FORD 5R110W Torqshift

NEW INTERMEDIATE FRICTIONS AND DIRECT CLUTCH HPOUSING FOR 2005

05-12

Figure 1
AUTOMATIC TRANSMISSION SERVICE GROUP

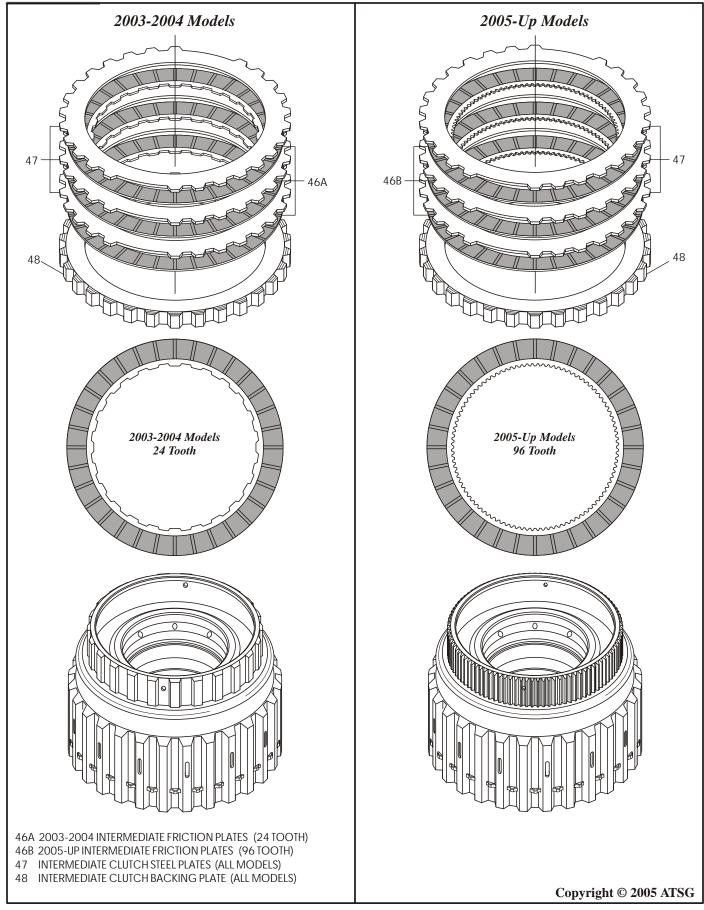
CHANGE: Beginning at the start of production for 2005, all 5R110W Torqshift transmissions were built with new design intermediate clutch friction plates and direct clutch housing (See Figure 1).

- (1) INTERMEDIATE CLUTCH FRICTION PLATES Changed from 24 internal teeth to 96 internal teeth, as shown in Figure 1.
- (2) DIRECT CLUTCH HOUSING Intermediate clutch hub on the direct clutch housing changed from 24 teeth to 96 teeth to accommodate the new design clutch plates, as shown in Figure 1.

Both pieces listed above will retro-fit back on all models when used as a service package.
